# Addendum No. 2

**PROJECT:** Vivie Nelson Care Center Renovation, Alexandria, MN

**From:** Wold Architects and Engineers

**Subject:** Addendum No. 2 for Bidding Documents for the
**Vivie**
**Nelson Care Center Renovation**
**Alexandria, Minnesota**

D1 SHORT STAY EXISTING MECHANICAL ROOM - NEW WORK PLAN
1/2" = 1'-0"

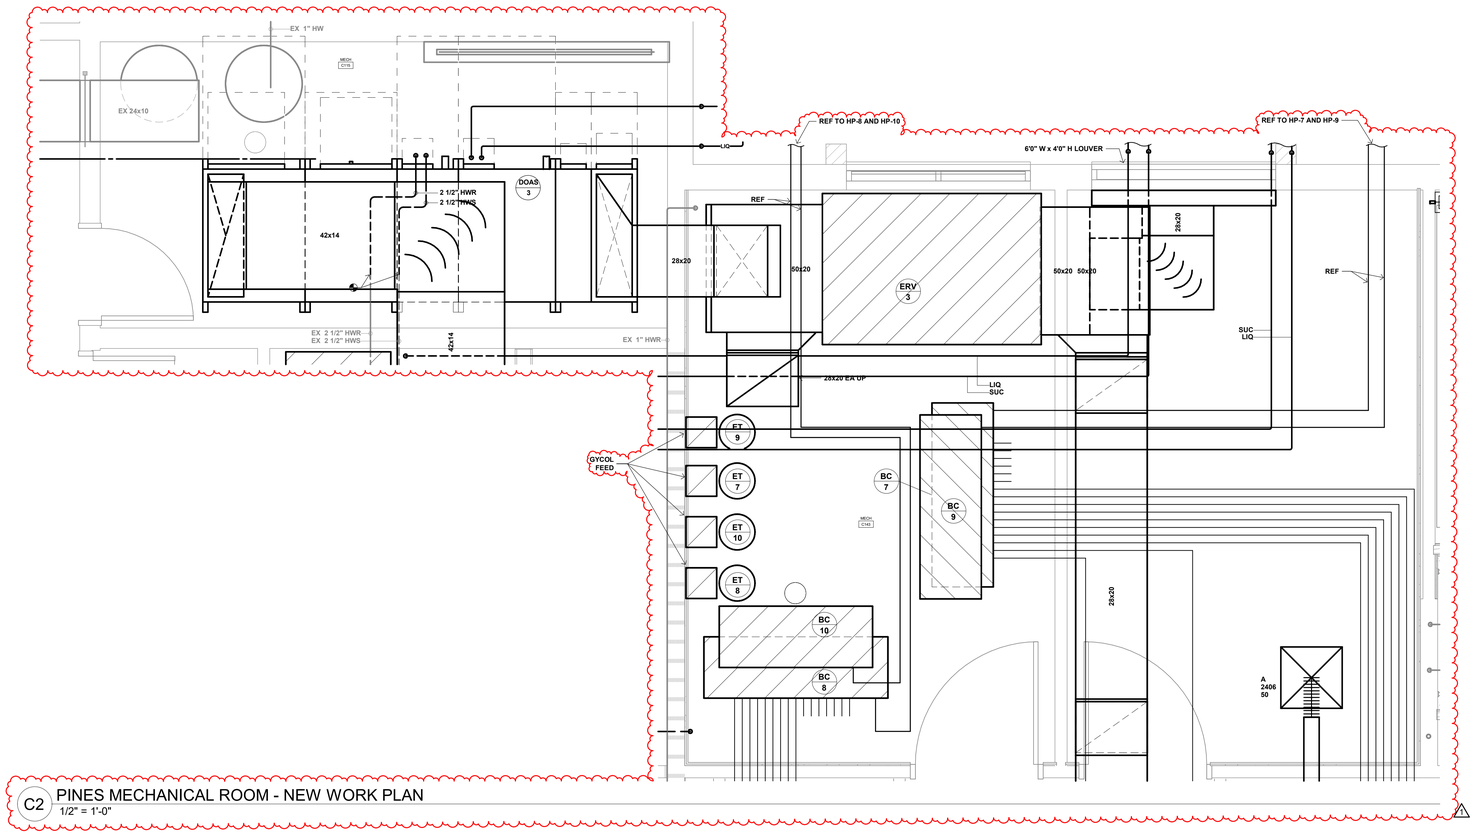
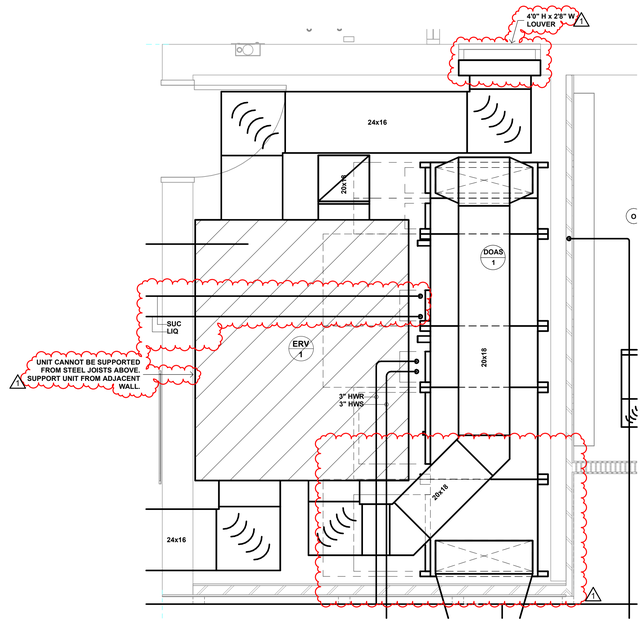
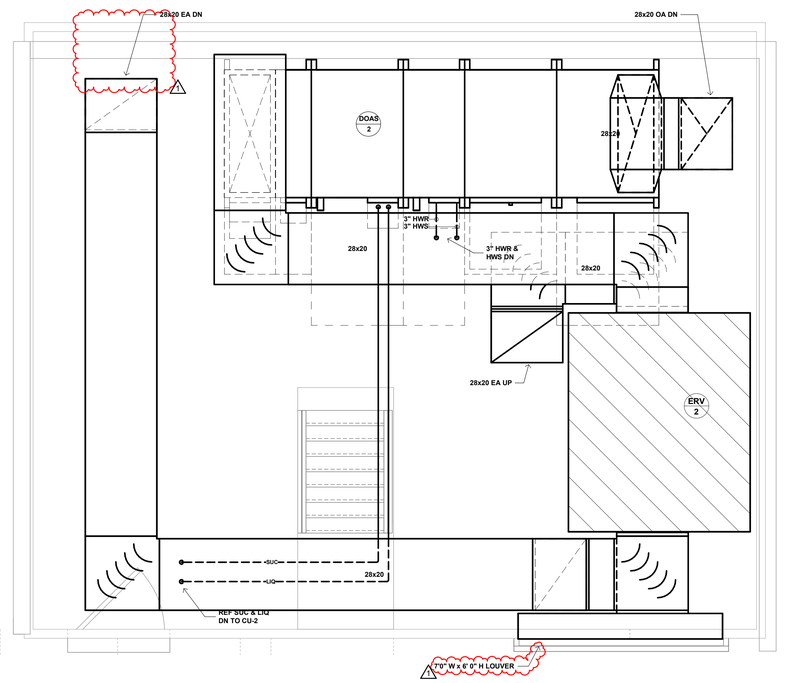
35. **DRAWING M7.01 - MECHANICAL ROOM NEW WORK PLANS**
    A. **Reissued this addendum**
       i. Overall mechanical room layouts adjusted to better fit equipment.
       ii. Refrigerant lines added and tagged to DOAS DX coils.
       iii. Exhaust and leak detection added to short stay existing mechanical room.
       iv. Intake louvers added and tagged on plans.

**E0.00**

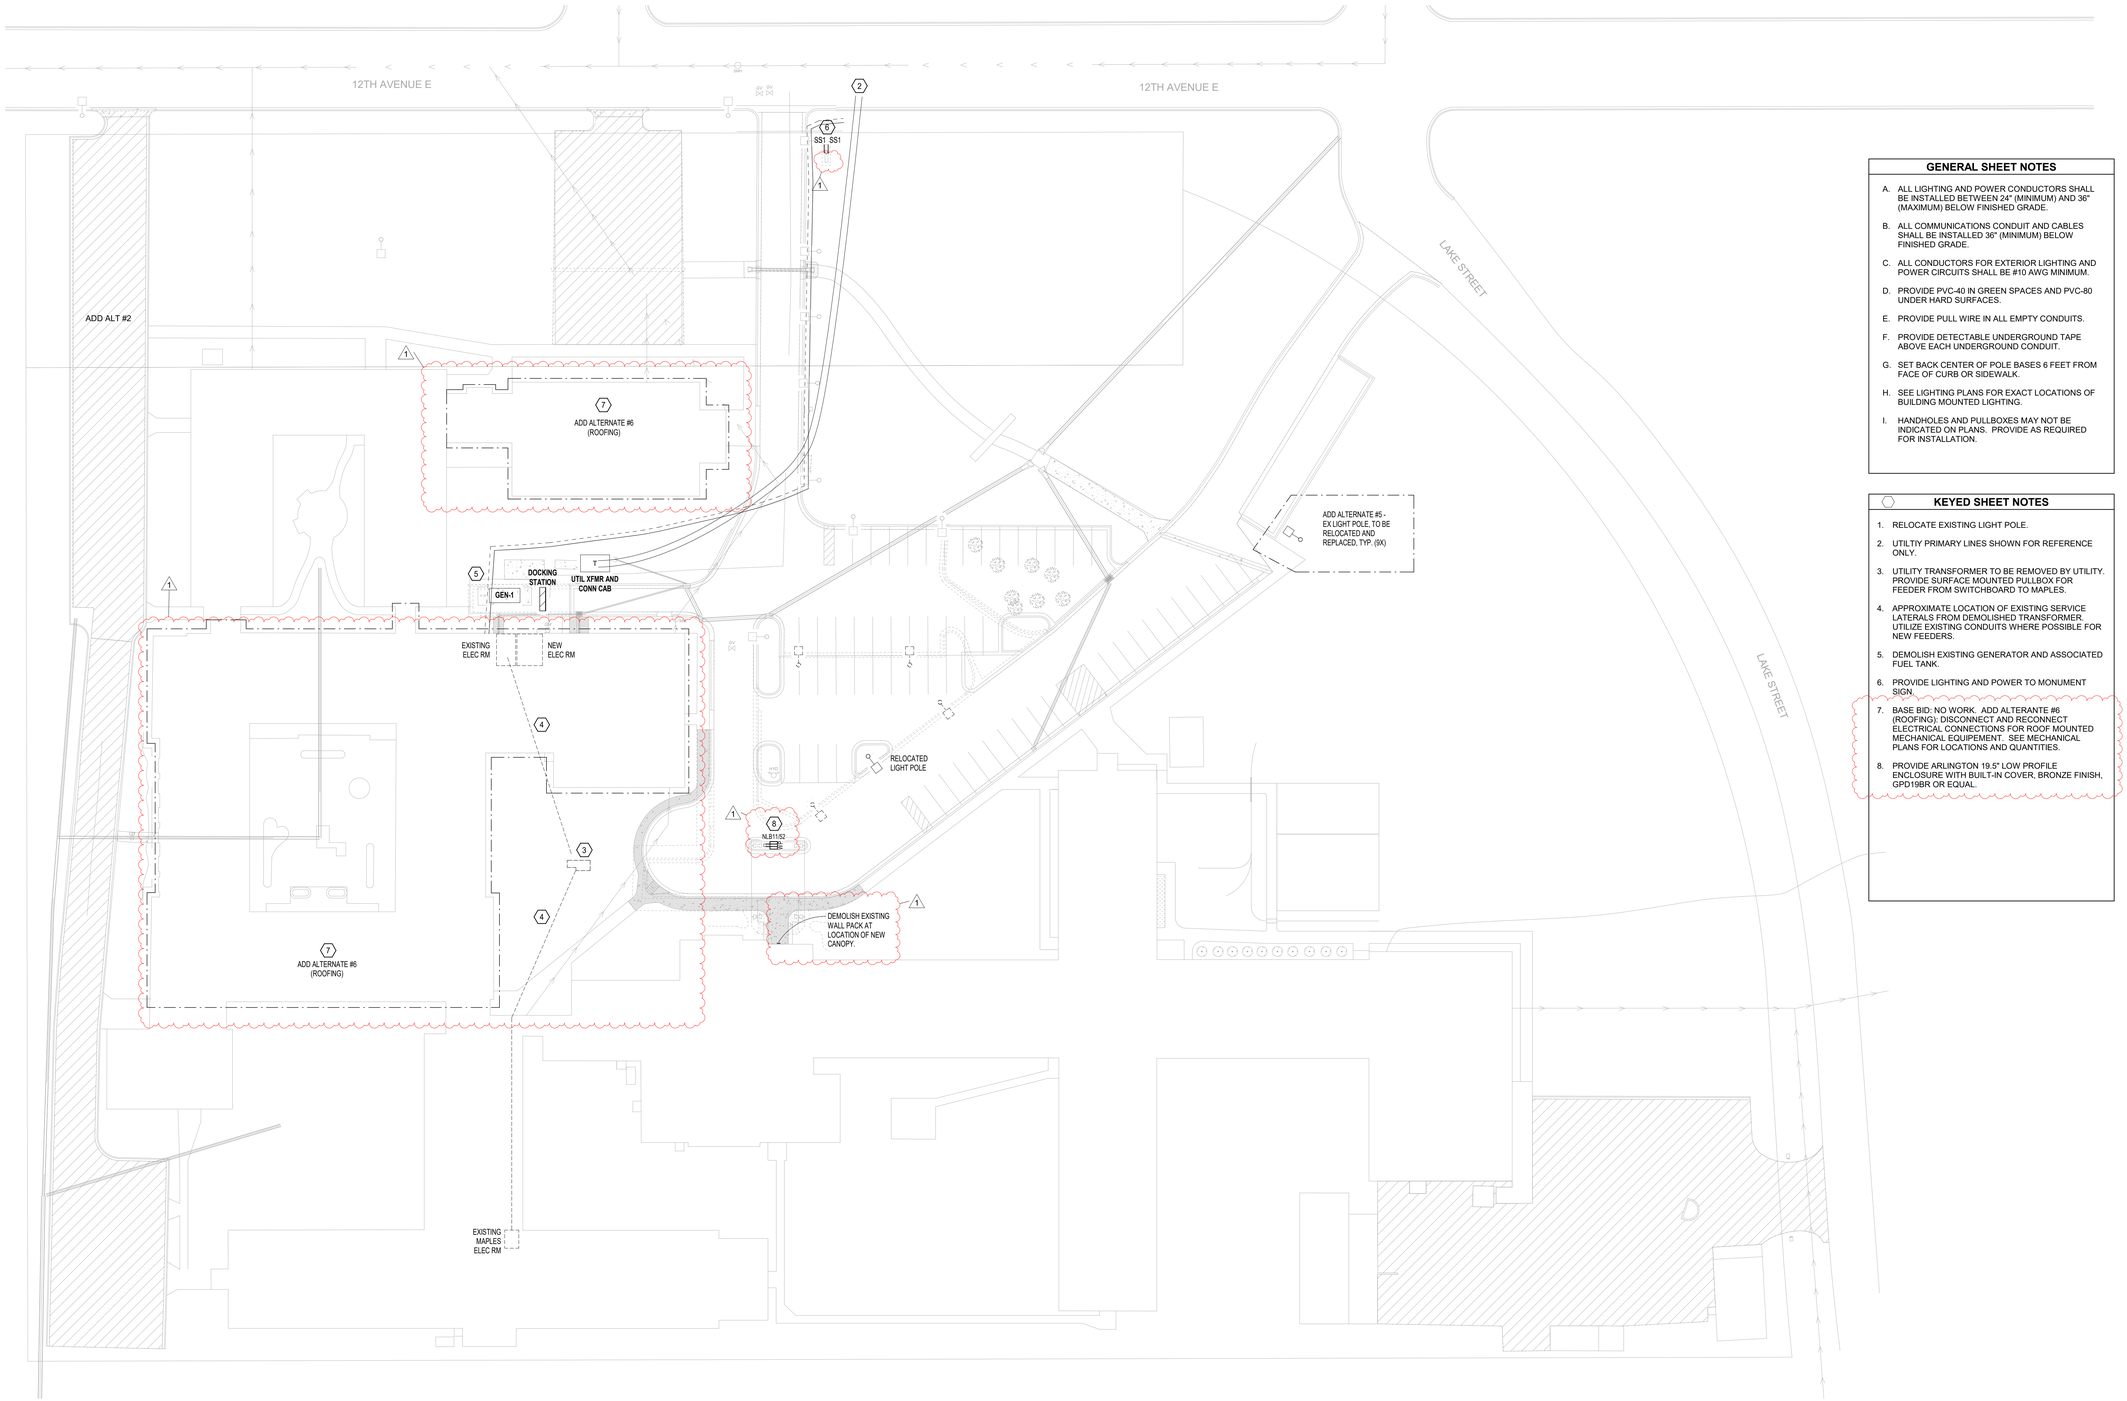
A. **Reissued this addendum**
       i. Added duress and lockdown button symbols.
39. **DRAWING E0.002 - ELECTRICAL SITE PLAN**
    A. **Reissued this addendum**

# E0.003

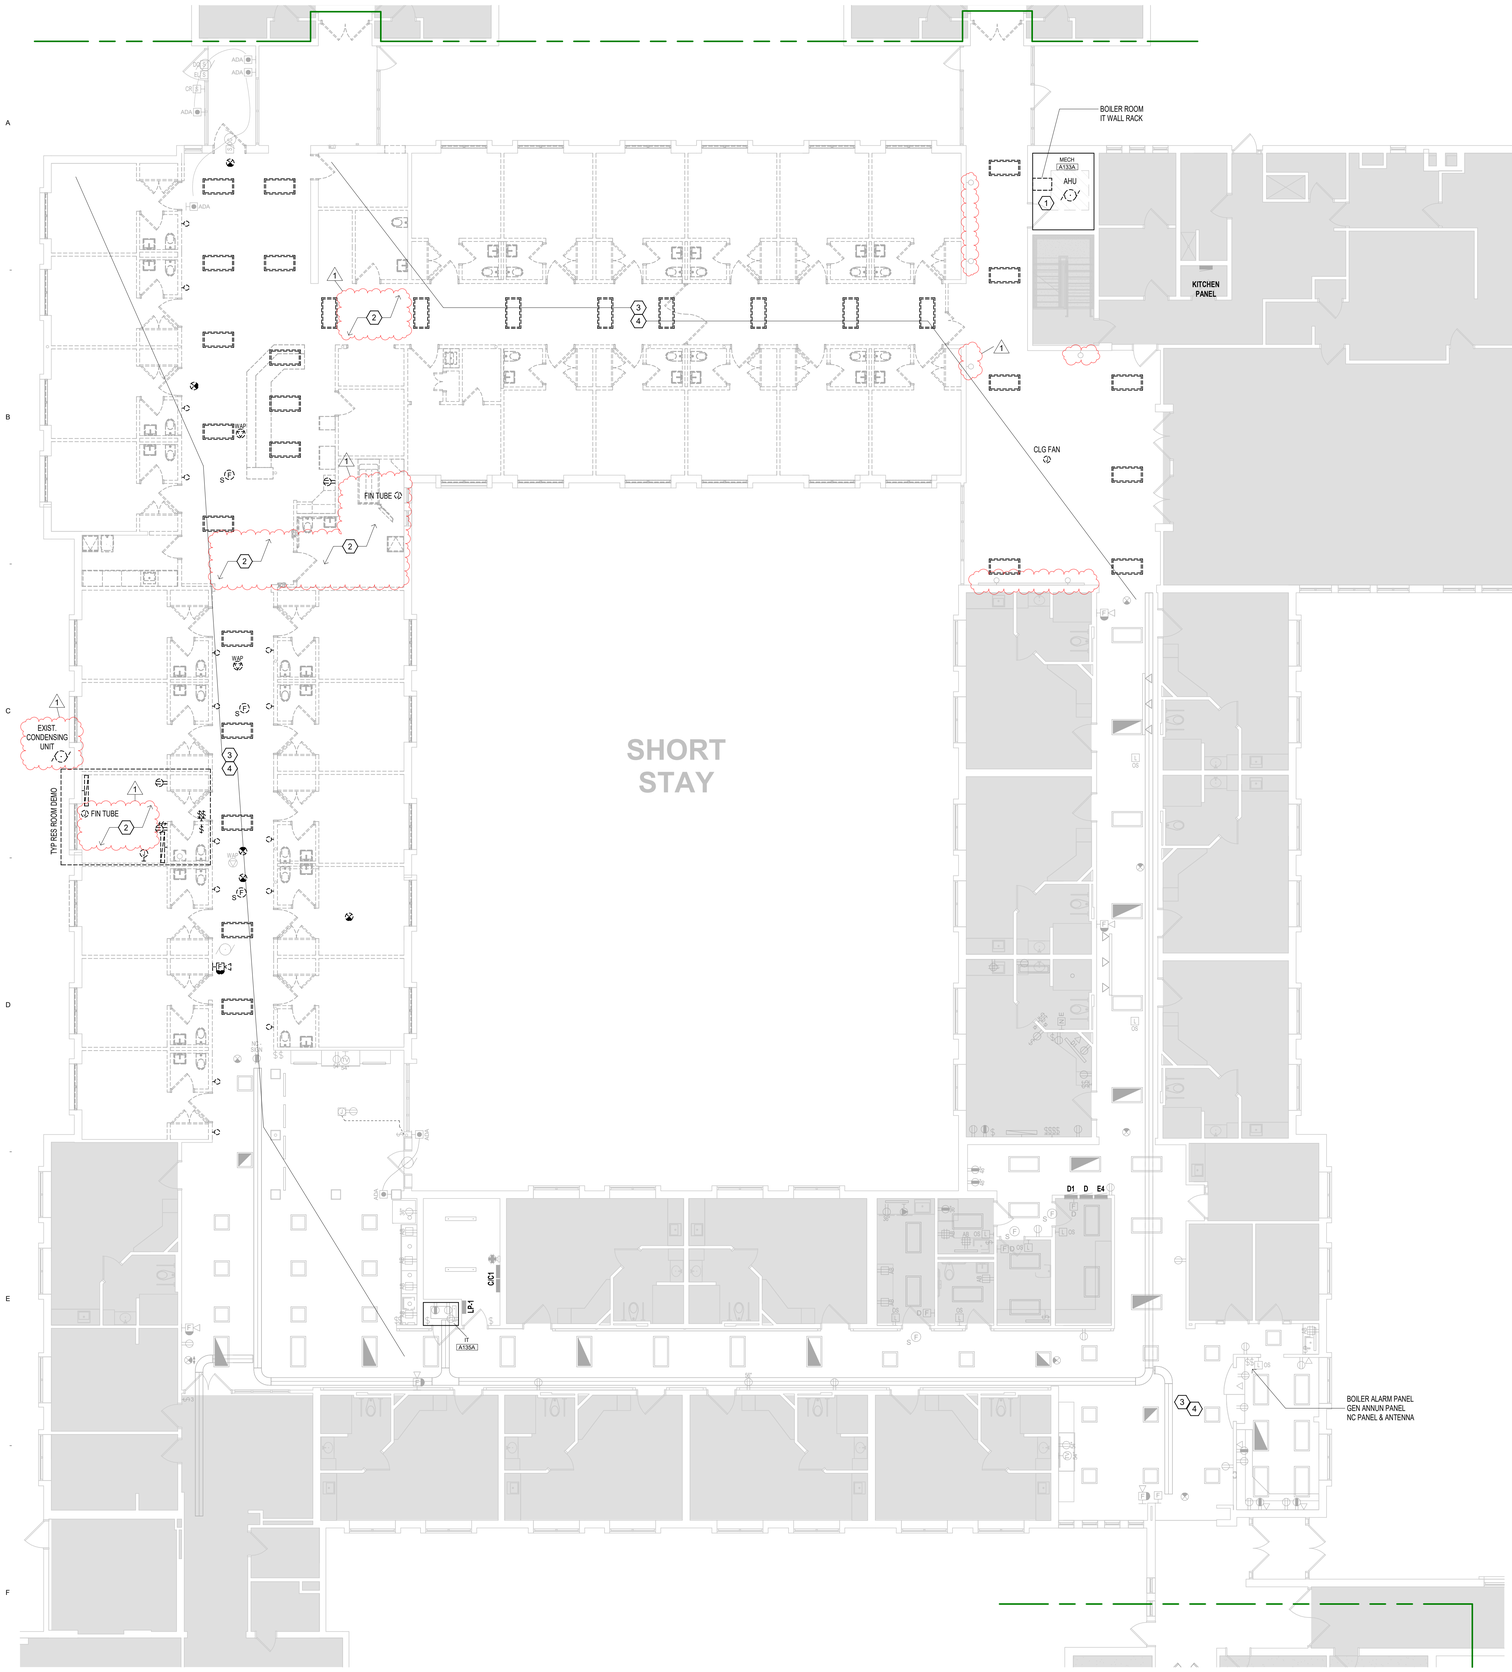
40. **DRAWING E0.003 - OVERALL PLAN**
    A. **Reissued this addendum**
        i. Added panel ELB11
41. **DRAWING E0.011a - ELECTRICAL DEMOLITION PLAN - AREA 'A'**
